# St. Evins Park, Monasterevin, Co. Kildare

Infrastructure Design Report  
(Part 8 Planning Submission)

2305-DOB-XX-SI-RP-C-0001

## Appendix G RSA Audit and Response

**Figure 4** Car park space for most western unit

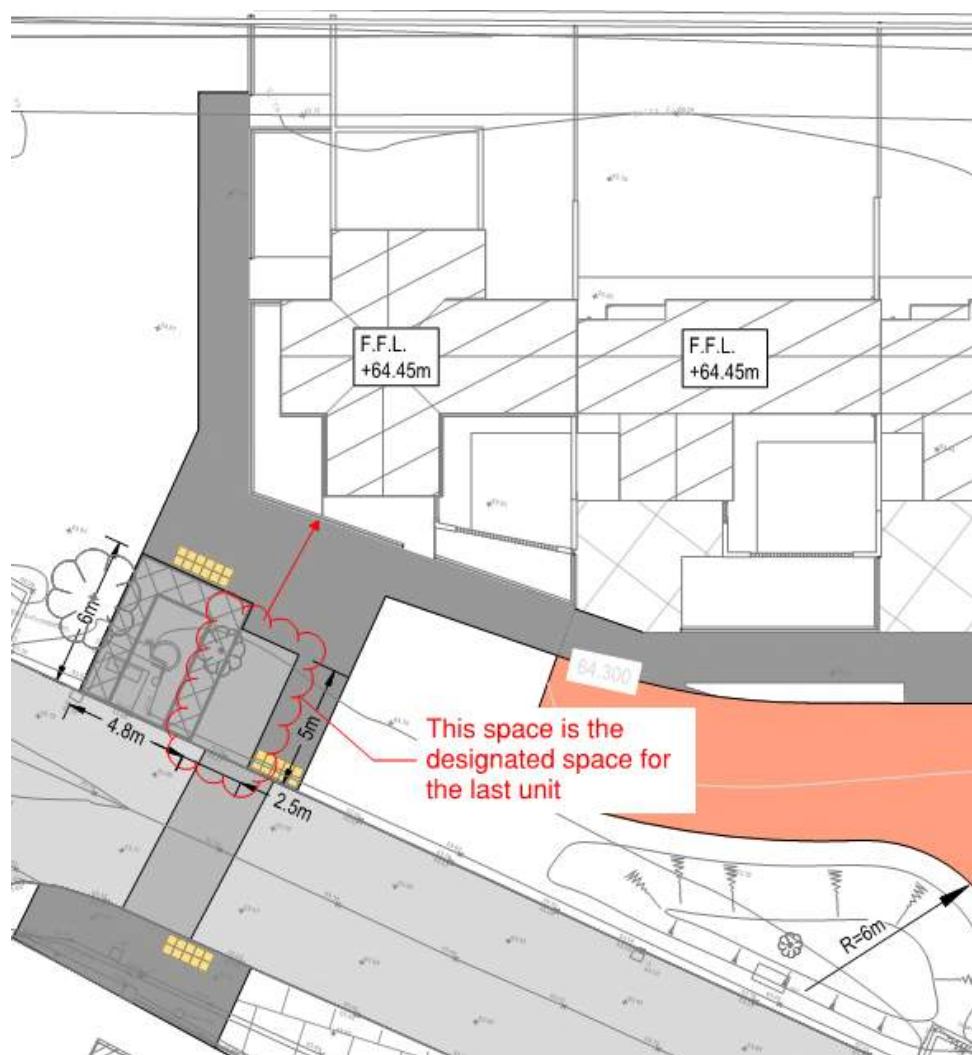
Secondly, highlighted in Figure 4 **Car park space for most western unit** below, parking for the most westerly unit is the car park next to the disable parking bay so access for this house is from the existing road.

**Figure 5** Extract from the updated Proposed Site Layout DR-C-0050 illustrating the new surface to be extended to include the new crossing

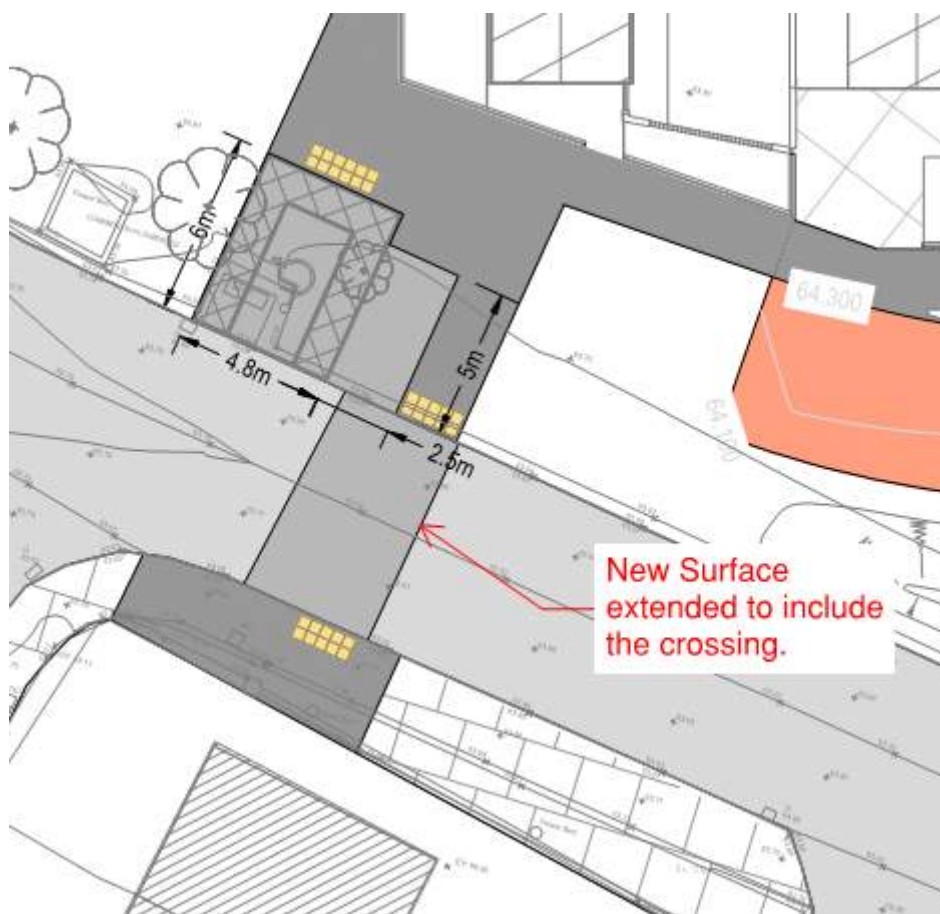
The designer agrees with this comment and the recommendation to extend the new surfacing over the entire crossing area. Please see updated Proposed Site Layout Sheet DR-C-0050.

**Figure 6- Kerb details**

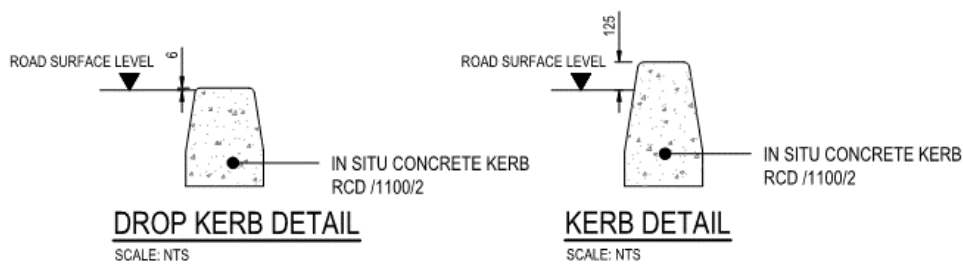
The designer agrees with the issue and the purposed recommendation. The kerb will be 75mm high for the length of the road similar to the opposite side of the road and there will be a 1m long dropped kerb every 5m along the length of the road.
